ADDENDUM NO. 4

Architect's Project No. 2024110 – ECC Rolla – Demolition Package

Project: Hazardous Materials Abatement and Selective Demolition at East Central College Rolla Campus

1 Level 01- Demolition - Overall Electrical/Technology
AD100E 1/16" = 1'-0"

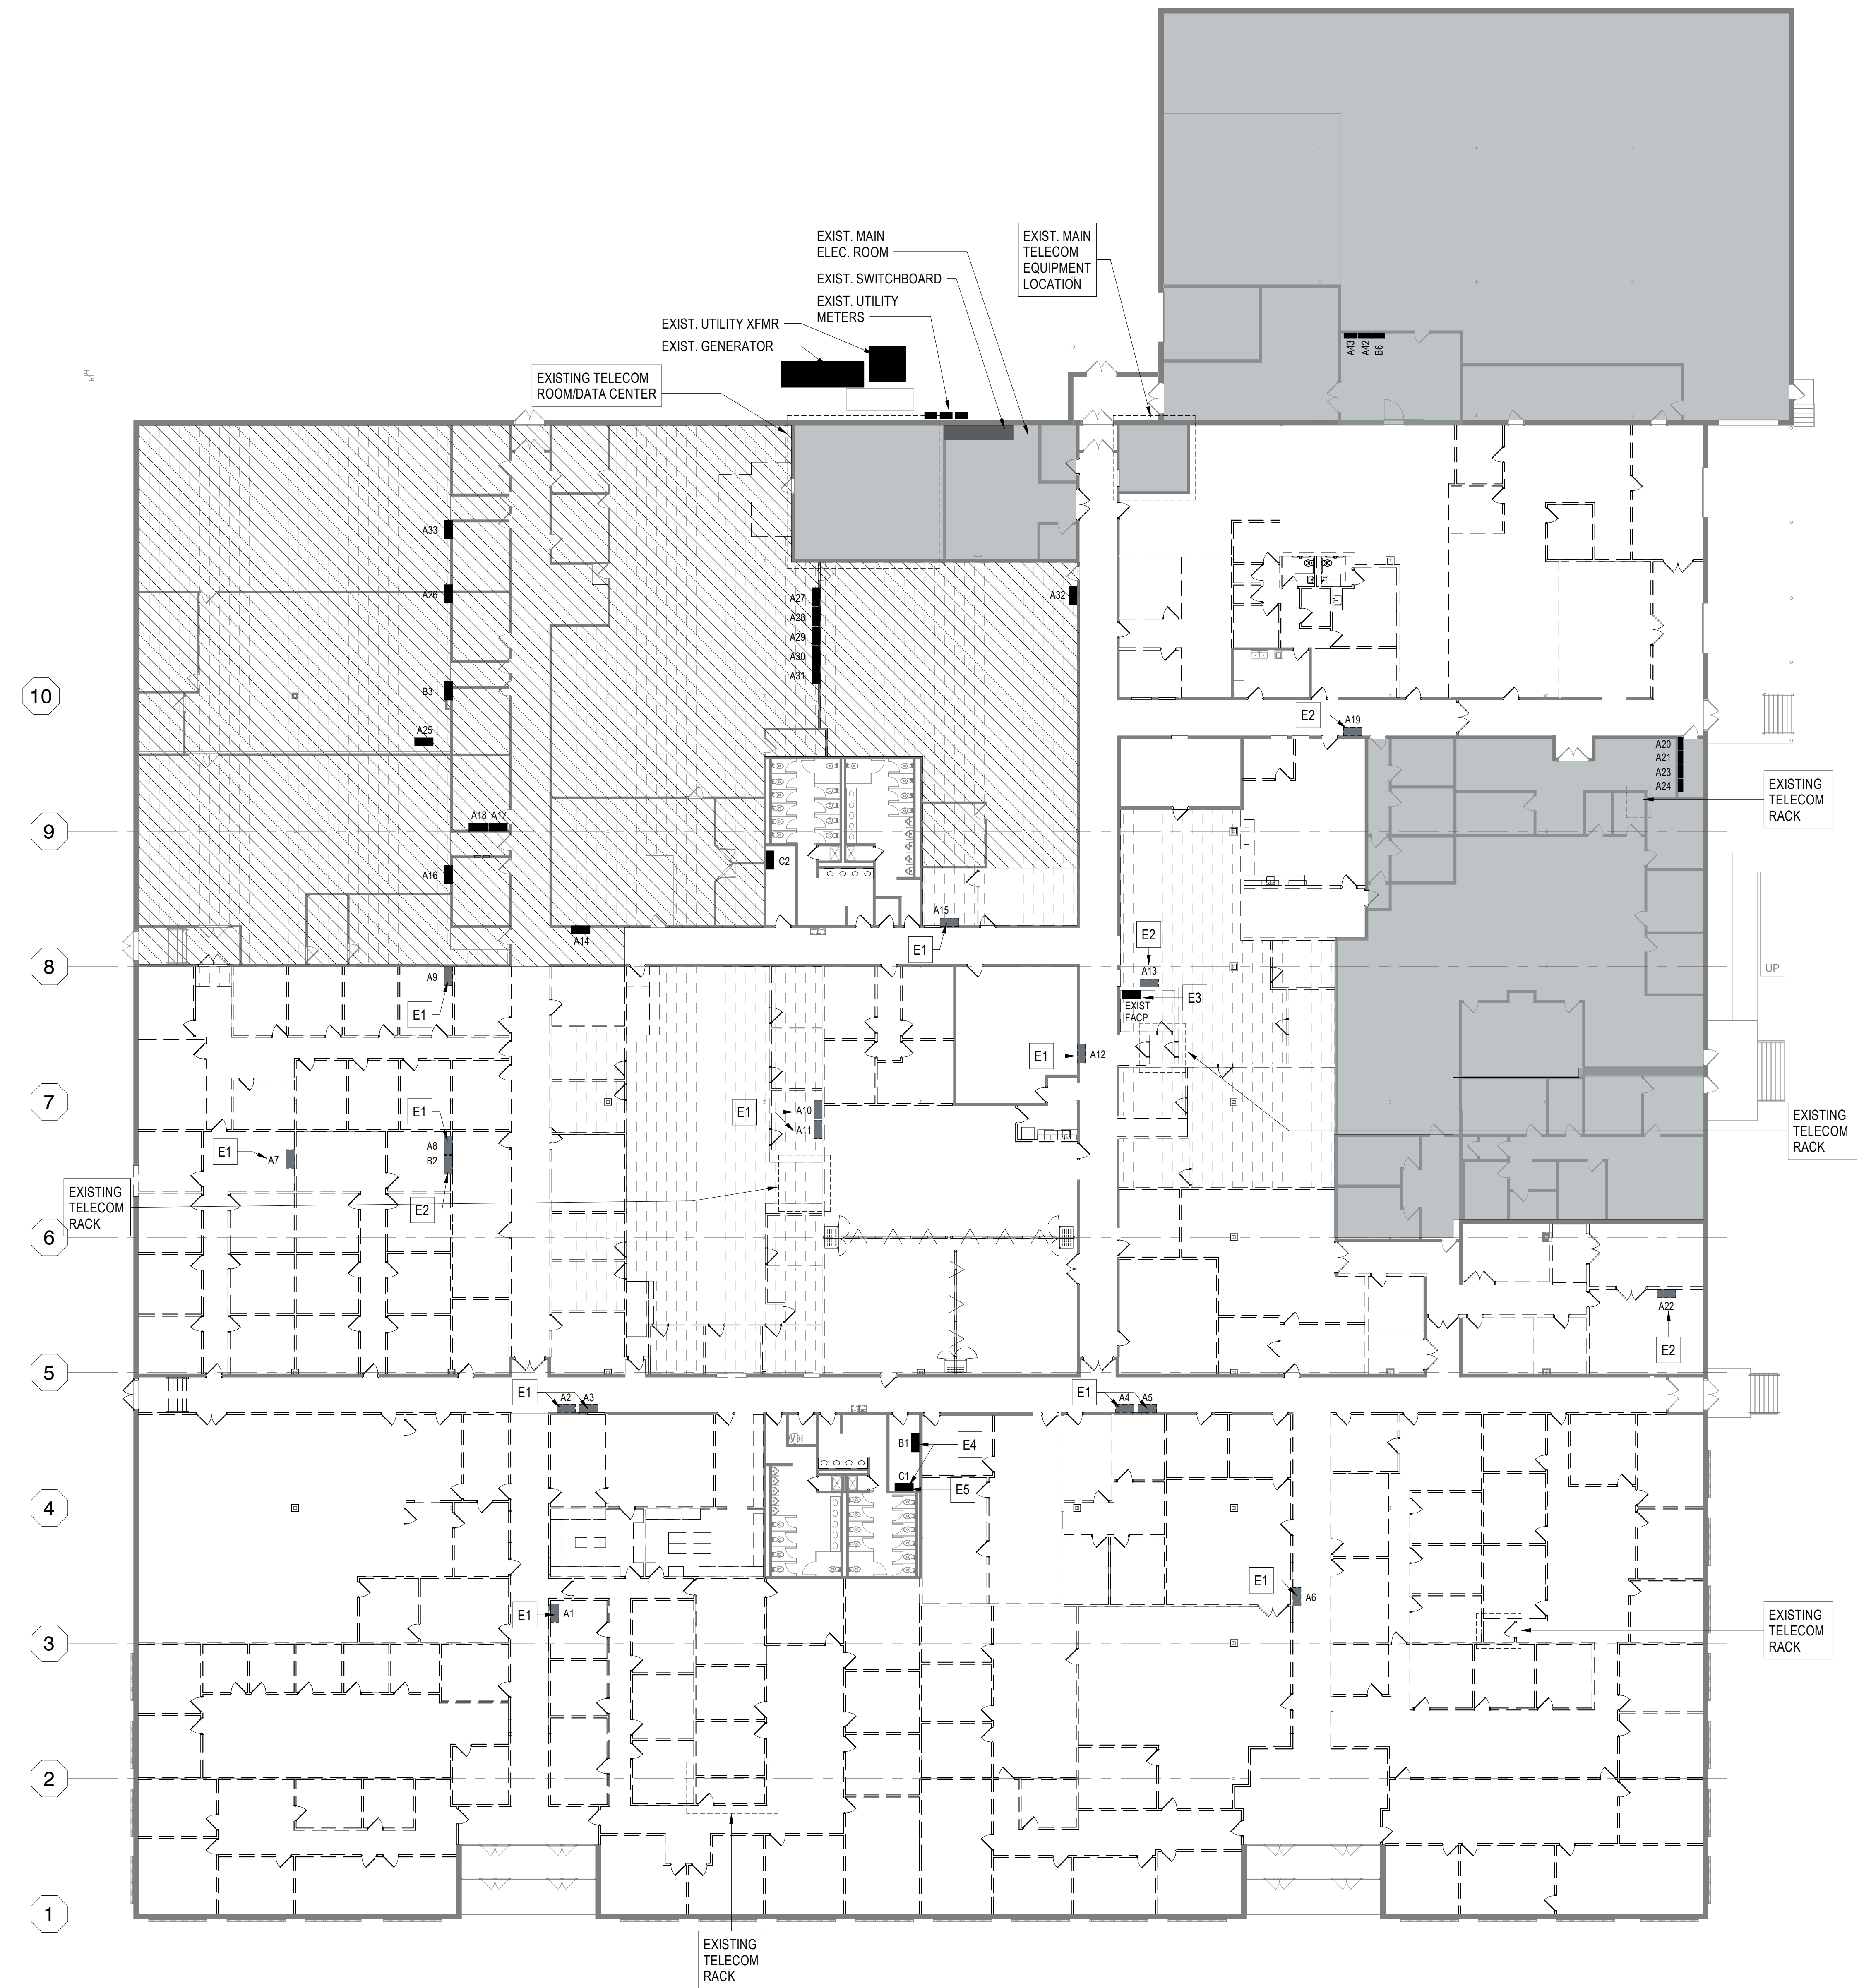
7 AD100E DEMOLITION PLAN – OVERALL ELECTRICAL AND TECHNOLOGY

7.1 Revise Electrical Scope of Work.

THE ELECTRICAL CONTRACTOR IS REQUIRED TO PROVIDE PRICING AND EXECUTE ALL NECESSARY LINE VOLTAGE POWER, LIGHTING, AND FIRE ALARM WORK ASSOCIATED WITH THE DEMOLITION PHASE. ALL GREY SHADED AND DIAGONALLY HATCHED AREAS ARE OUT OF THE SCOPE AREA OF THIS PHASE OF DEMOLITION. GREY SHADED AREAS WILL REMAIN OPERATIONAL AND ALL OUTAGES SHALL BE COORDINATED WITH THE OWNER. AREAS OF DEMOLITION SHALL BE MADE ELECTRICALLY SAFE FOR DEMOLITION. ALL ELECTRICAL DEVICES, FIRE ALARM DEVICES, LIGHTING FIXTURES, AND ELECTRICAL EQUIPMENT IN AREAS OF DEMOLITION ARE TO BE REMOVED COMPLETE BACK TO SOURCE.

THE CONTRACTOR SHALL VERIFY PANELS WITHIN DEMOLITION SCOPE DO NOT SUPPLY ANY LOADS IN THE GREY SHADED OR DIAGONALLY HATCHED AREAS. WHERE NOTED PER KEYNOTE E2. CONTRACTOR SHALL DETERMINE IF CIRCUIT TRACING IS REQUIRED IN EXCESS OF WHERE REQUIRED BY KEY NOTE E2 AND NOTIFY OWNER, ARCHITECT, AND ENGINEER. WHERE A PANEL IS DETERMINED TO SUPPLY A LOAD NOT WITHIN THE AREA OF DEMOLITION, THE CONTRACTOR SHALL CONTACT THE OWNER, ARCHITECT, AND ENGINEER TO COORDINATE DISCONNECTION AND RECONNECTION TO AN ACCEPTABLE PANEL OUTSIDE THE AREA OF DEMOLITION TO MAINTAIN POWER.

FIRE ALARM IN GREY SHADED AND DIAGONALLY HATCHED AREAS SHALL BE MAINTAINED AND PROTECTED IN PLACE FOR CONTINUITY AND OPERATION THROUGH THE DEMOLITION AND RENOVATION WORK. IF THE FIRE ALARM SYSTEM NEEDS TO BE TAKEN OUT OF SERVICE WHILE THE BUILDING IS OCCUPIED, CONTACT OWNER A MINIMUM OF TWO WEEKS IN ADVANCE. PROVIDE FIRE WATCH PER NFPA 72 AND IF THERE IS 8 OR MORE HOURS OF DOWNTIME ON CONSECUTIVE DAYS DURING OCCUPIED HOURS.

Sheet Number: **AD105**

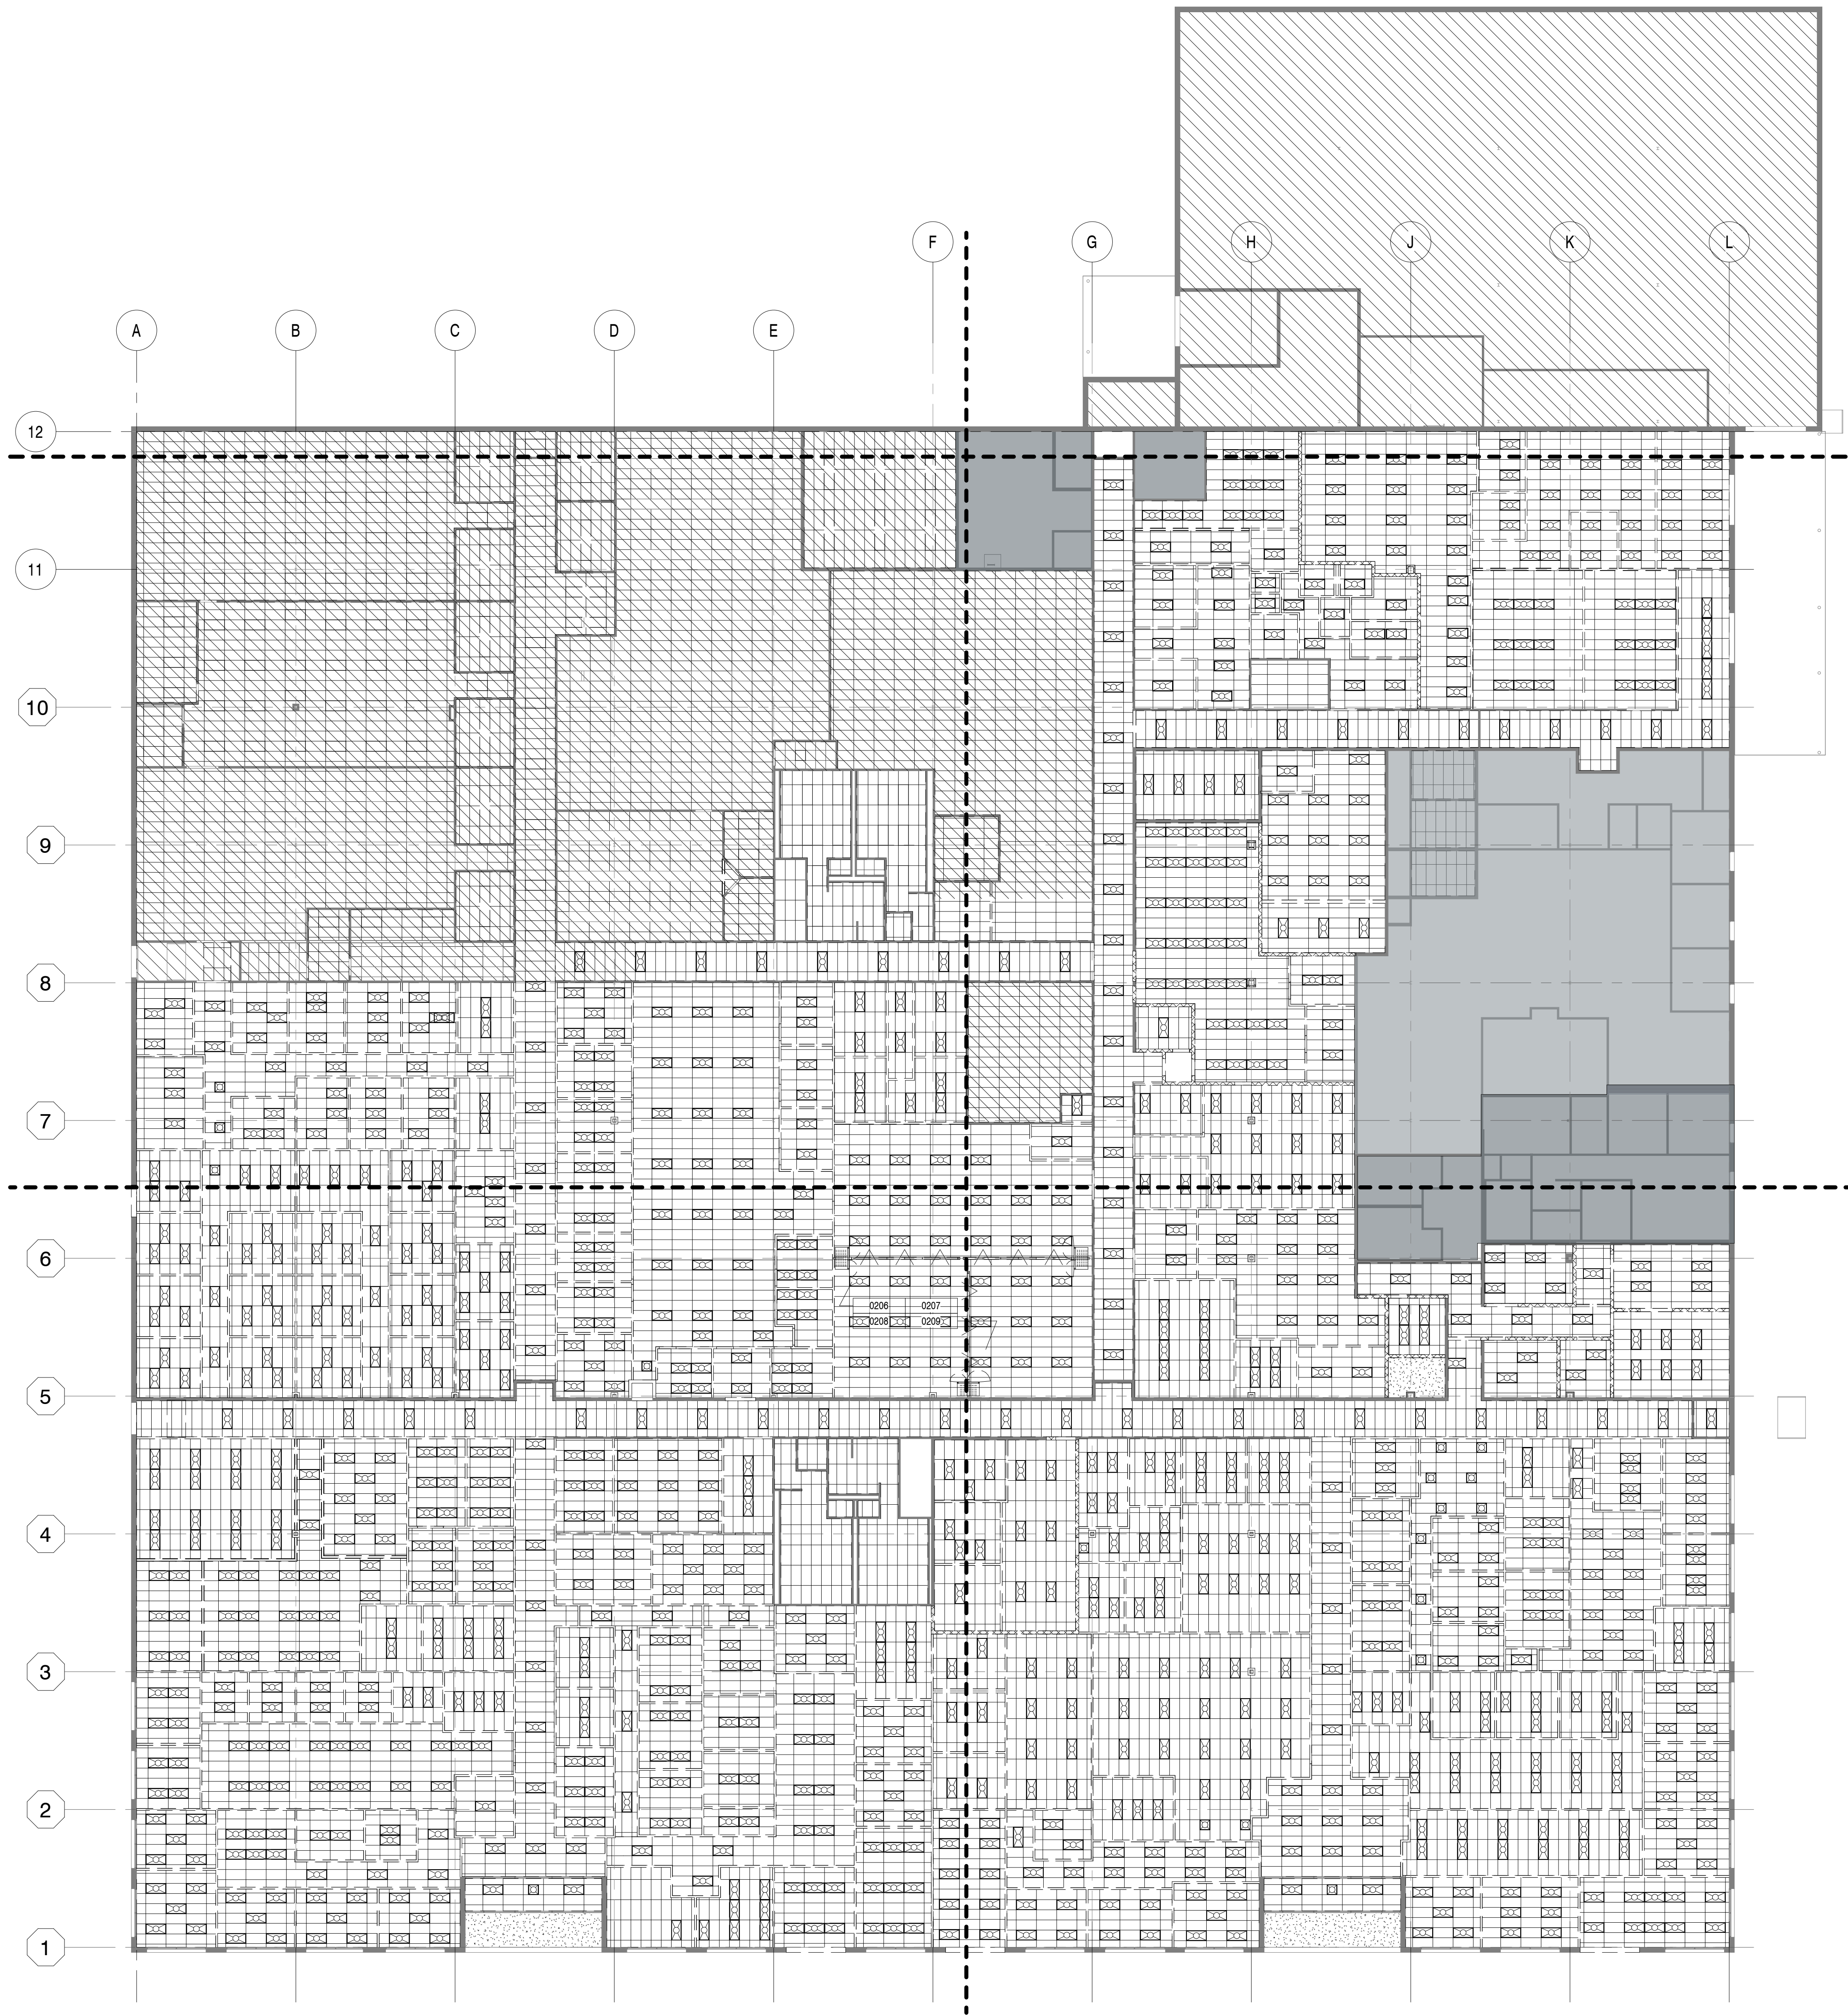
12 AD105 DEMOLITION PLAN AREA E

12.1 Revise Keyed Notes

12.2 Revise Legend

12.3 Revise floor plan as indicated
